DOCUMENT 00 90 00
ADDENDUM

ADDENDUM NO. [2] **Date: February 24, 2021**

RE: WESTERN TECHNICAL COLLEGE
SPARTA PUBLIC SAFETY EXPANSION
11177 COUNTY HWY A
SPARTA, WISCONSIN 54656
HSR PROJECT NO. 20028

This Addendum consists of [5] pages, [1] Revised Bid Form, [1] specification section [21] 30 x 42 drawings and [1] prior product approval.

1 SECOND FLOOR POWER PLAN - AREA B
E203 SCALE: 1/8" = 1'-0"
20-07-E-PP02

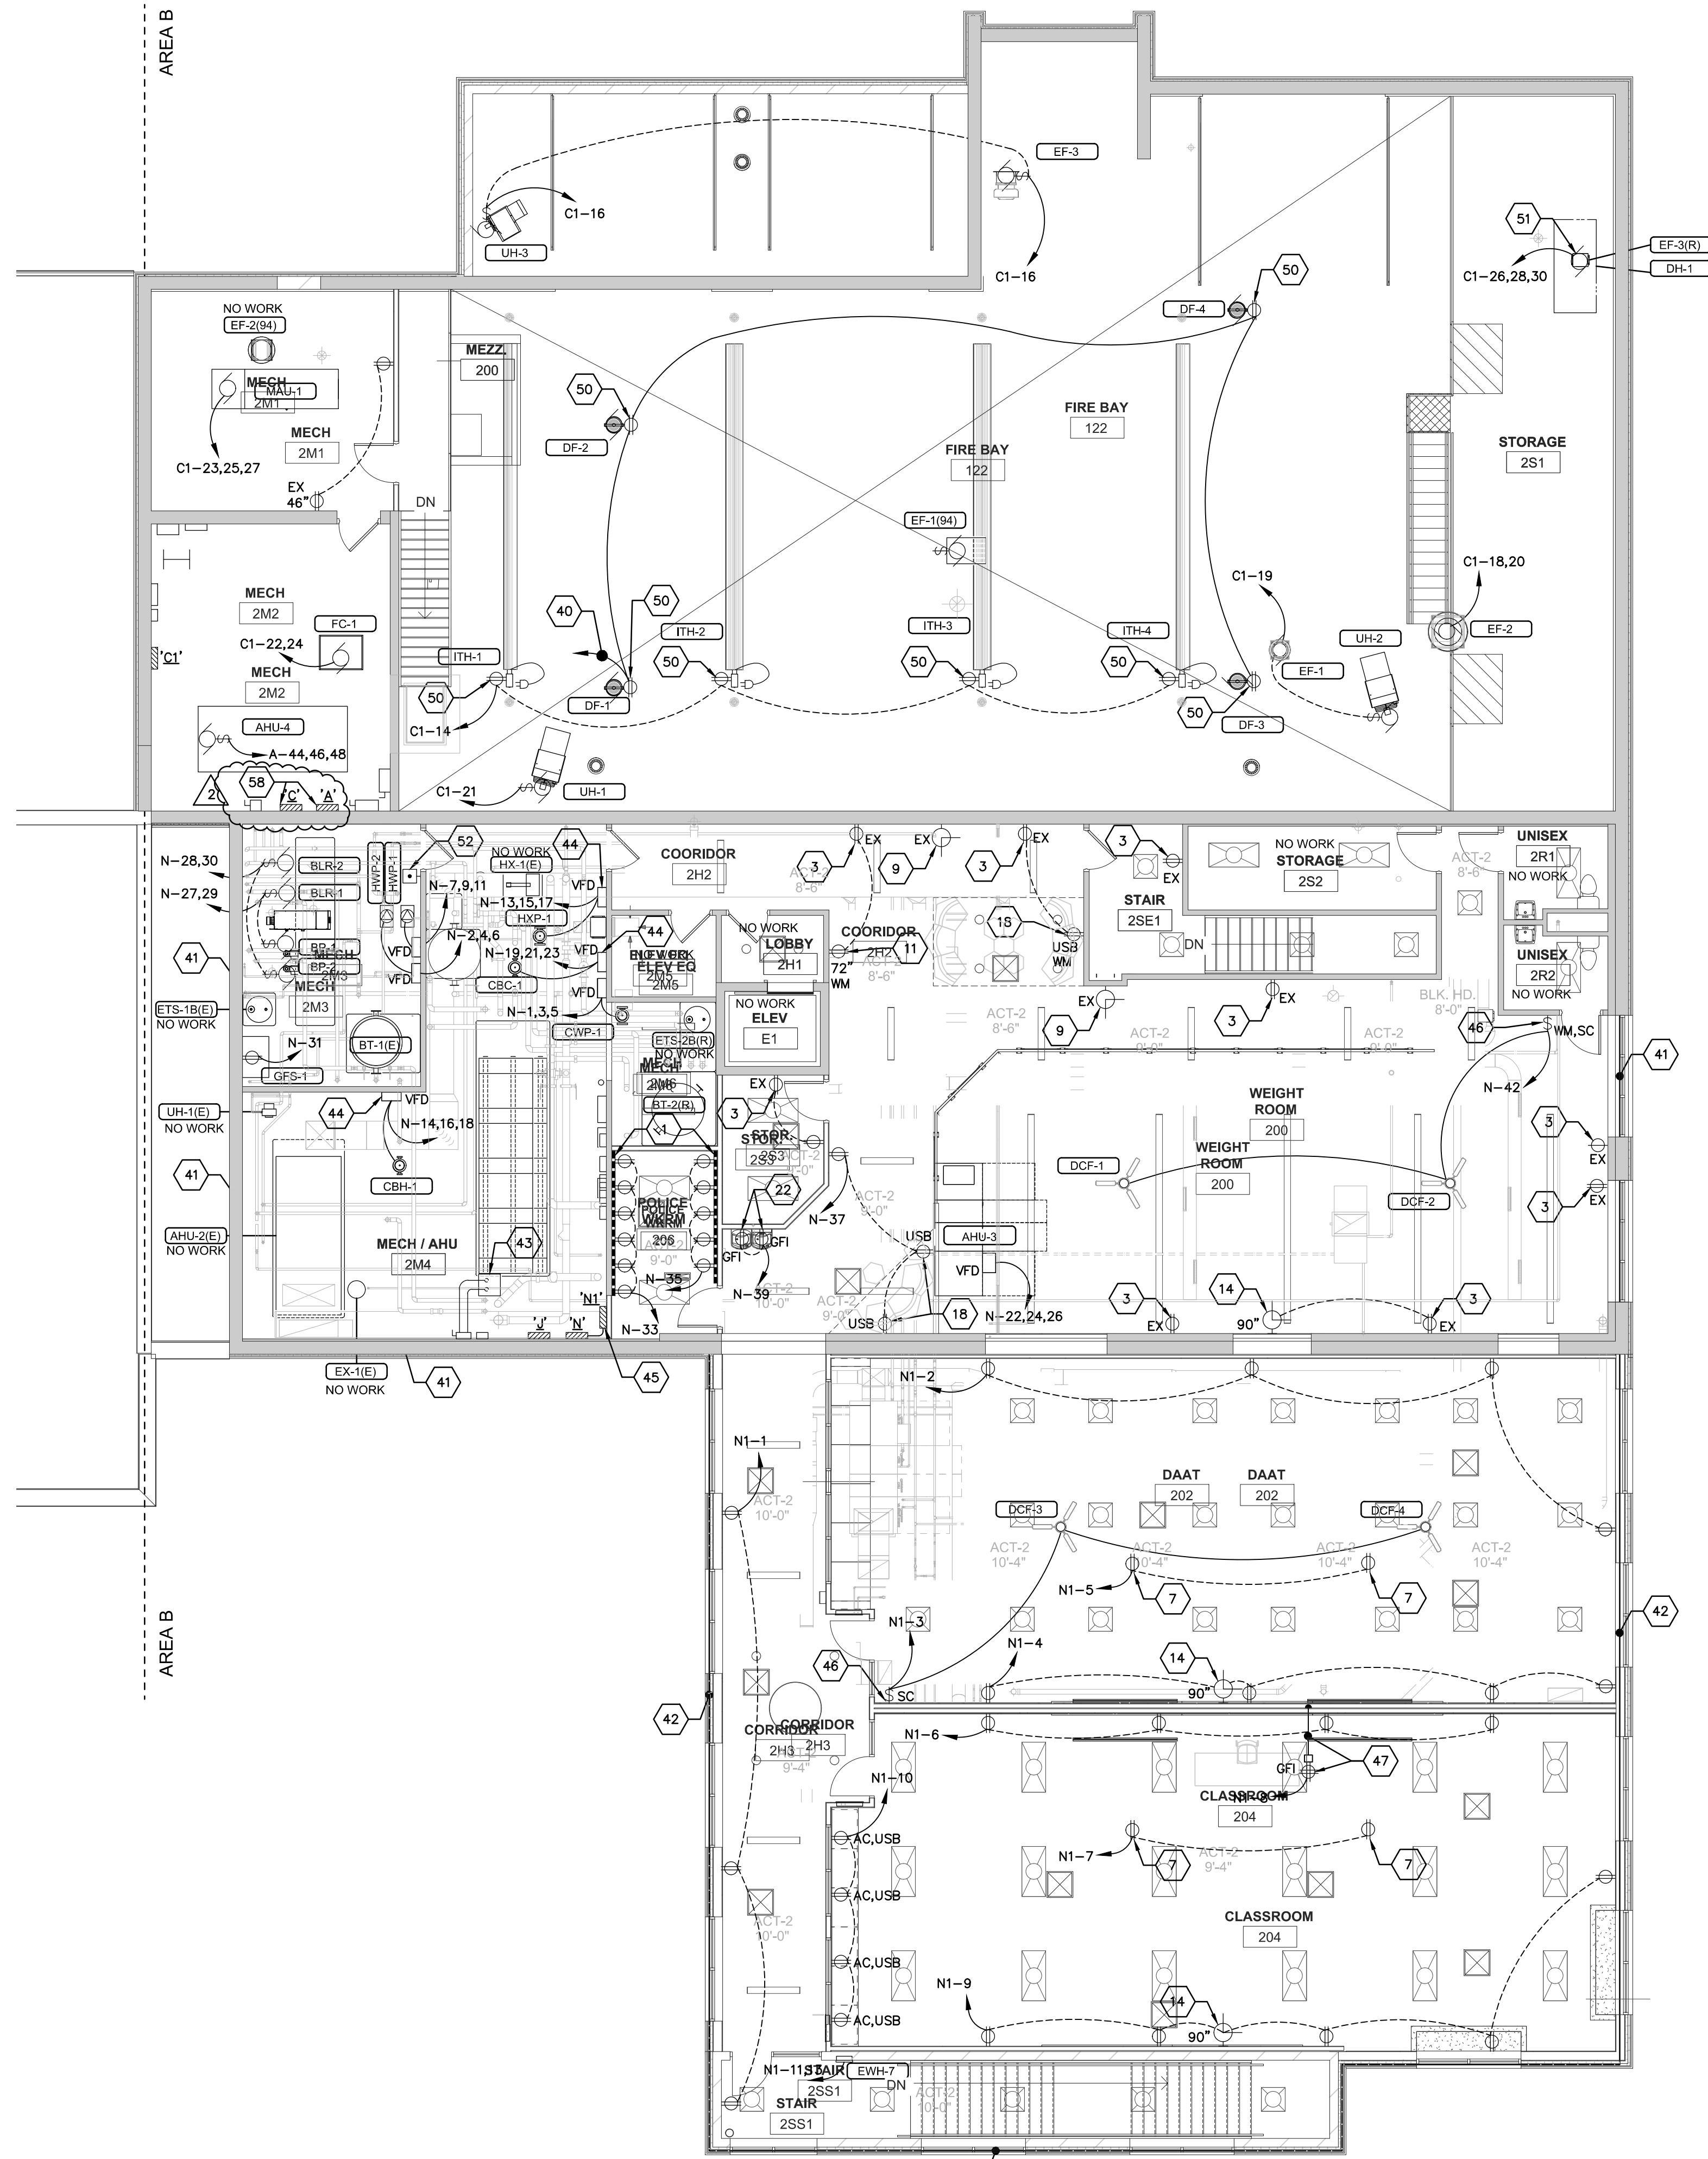
31. Sheet E203 SECOND FLOOR POWER PLAN – AREA B 30 X 42 attached hereto

- a. Revisions clouded on Drawing
- b. Refer to Mechanical Room #2M2; Existing 225 amp., 120/208VAC, 3-Phase, 4-Wire General Electric Panelboards 'A' and 'C' shall be disconnected, removed and replaced with new Square 'D' panelboards as noted on Partial Electric Riser Diagram 2/E201. Refer to clouded change and keyed note #58 dated 2-24-2021.

1 FIRST FLOOR LOW VOLTAGE PLAN - AREA A
SCALE: 1/8" = 1'-0"
20-07-E-LV01

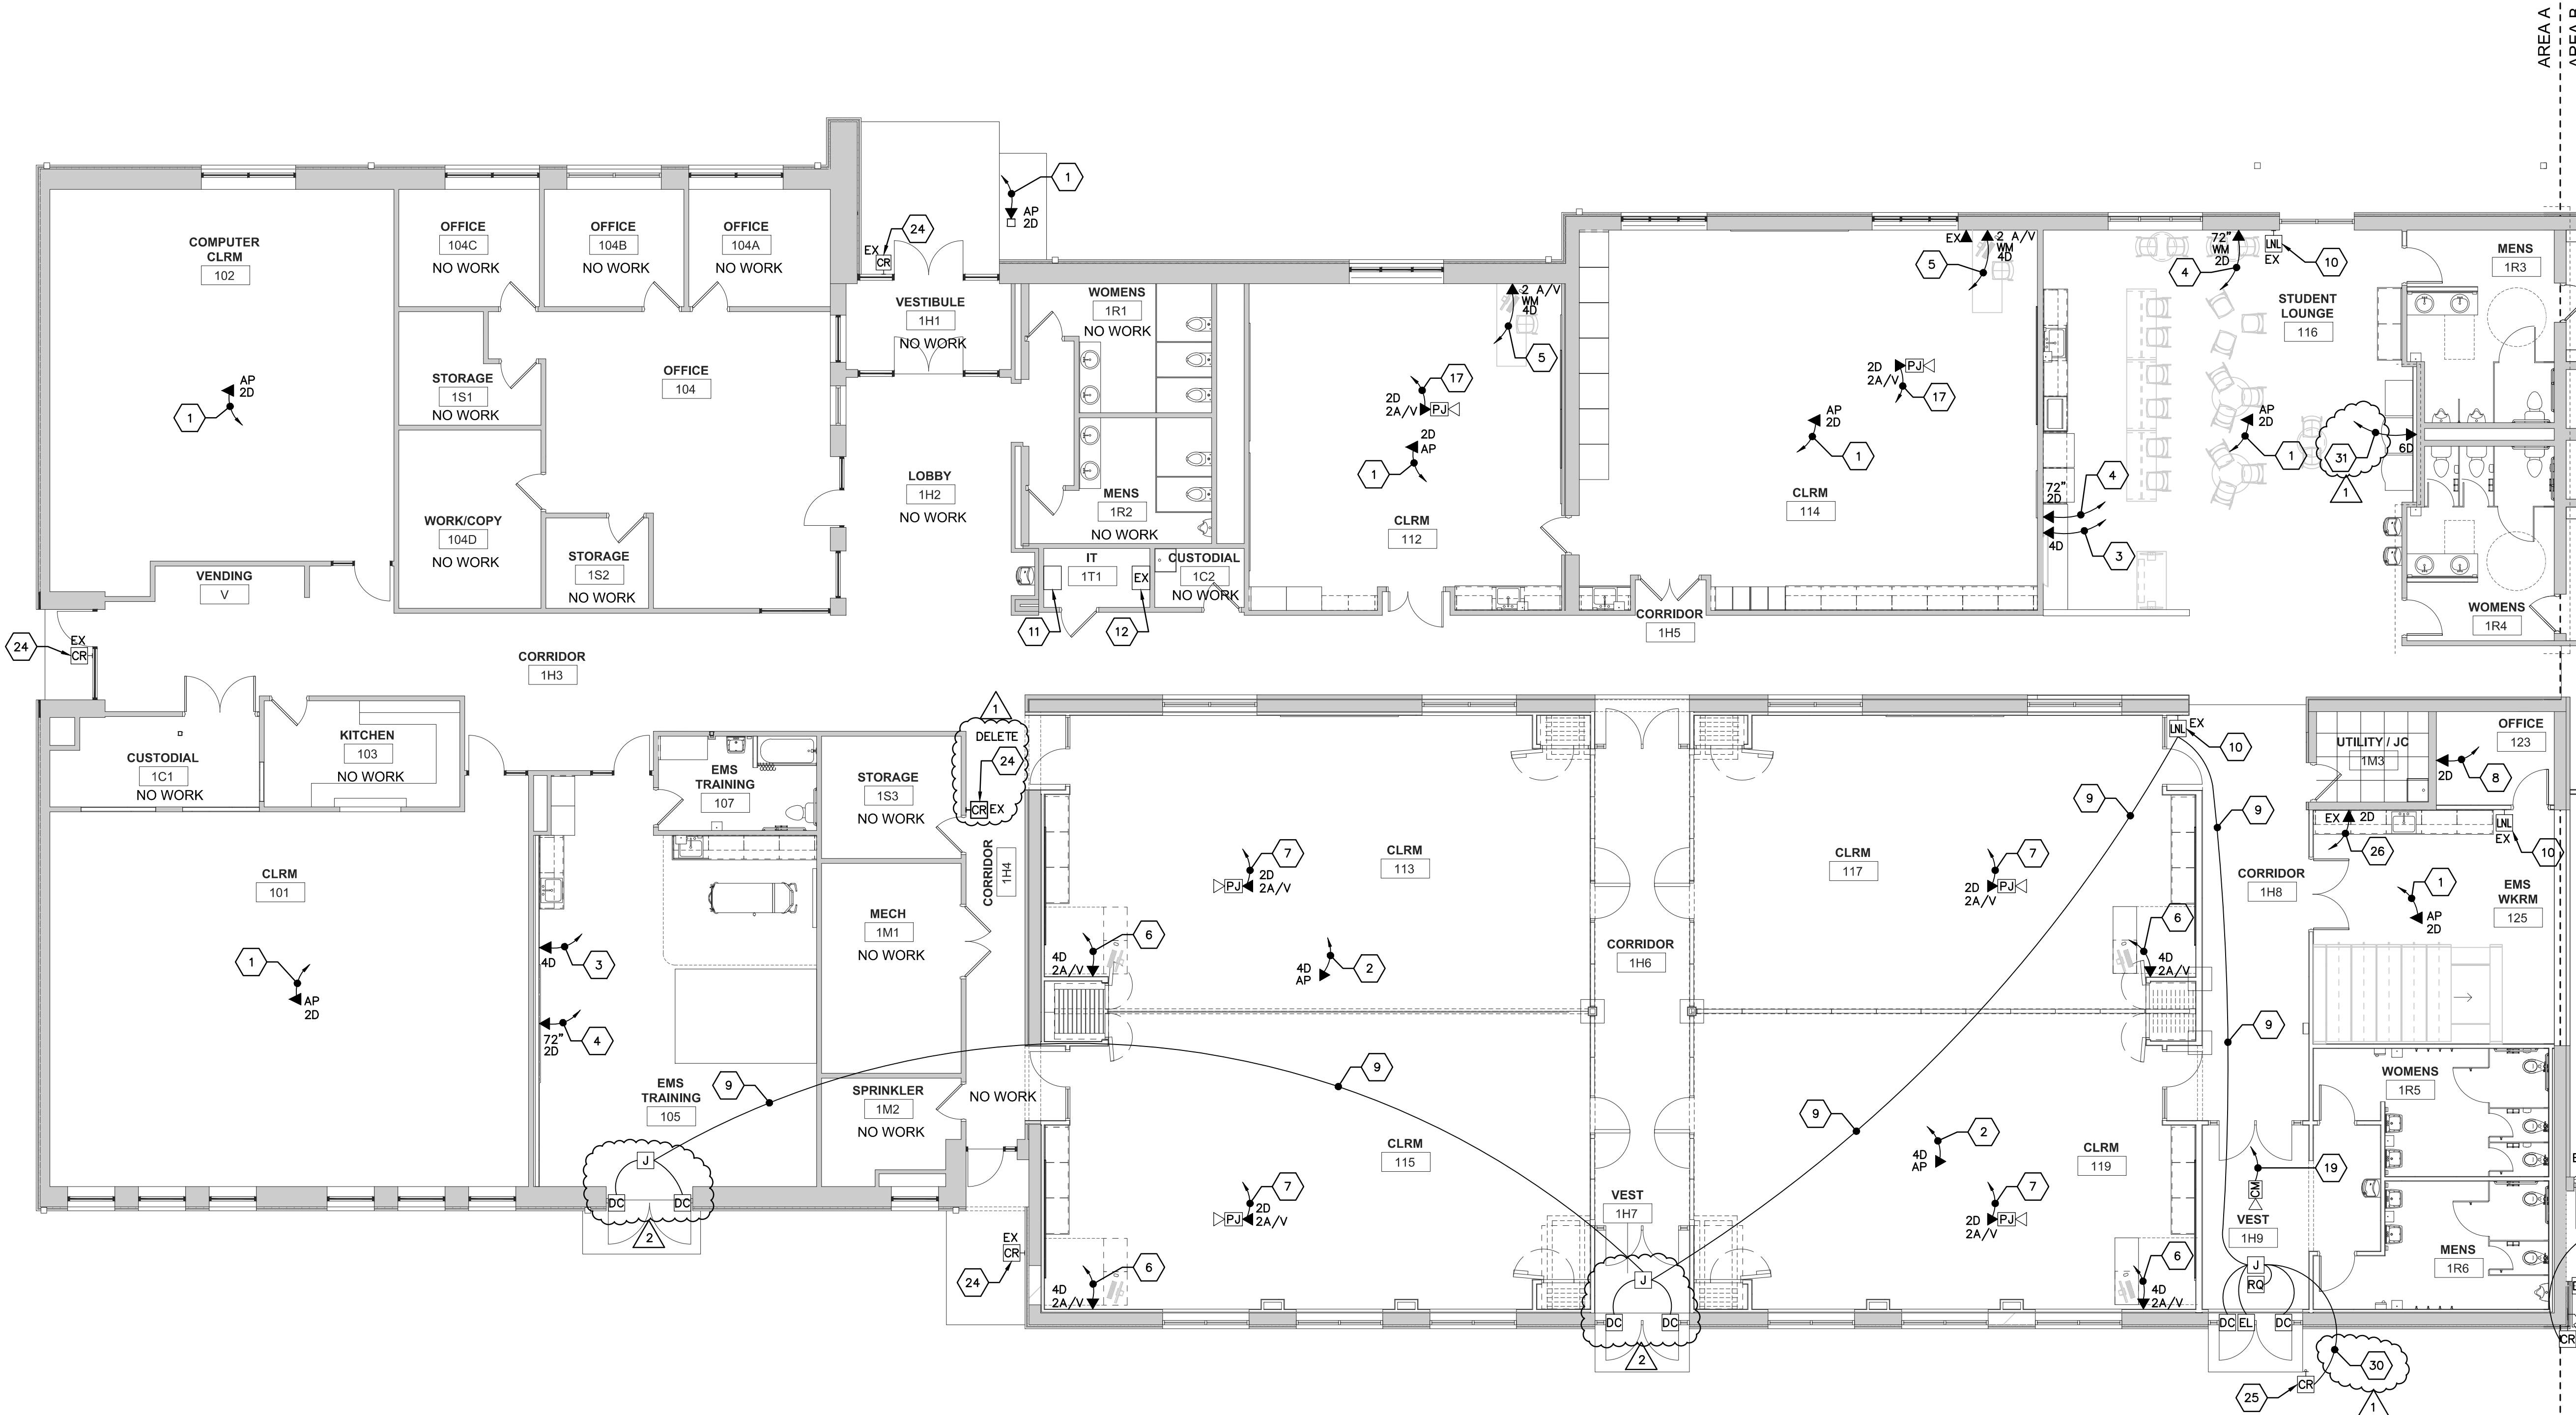
32. Sheet E301 FIRST FLOOR LOW VOLTAGE PLAN – AREA A 30 X 42 attached hereto

- a. Revisions clouded on Drawing
- b. Refer to EMS Training Room #105; Door Position Contact Switches have been added to the double exterior door. Refer to clouded change dated 2-24-2021.

- c. Refer to Vestibule Room #1H7; Card Reader, Electric Strike, and Request-to-Exit devices have been deleted from the double exterior door. Refer to clouded change dated 2-24-2021. Contact Position Switches remain.

- d. In IT Room #1TI; Empty keyed note symbol pointing at room number has been deleted and erased from the drawing. Refer to clouded change dated 2-22-2021.

- e. Refer to General Note A; Provide the following Hubbell, Nextspeed CAT6A Cables for this project: This note shall appear on All Low Voltage Sheets E301, E302 and E303:
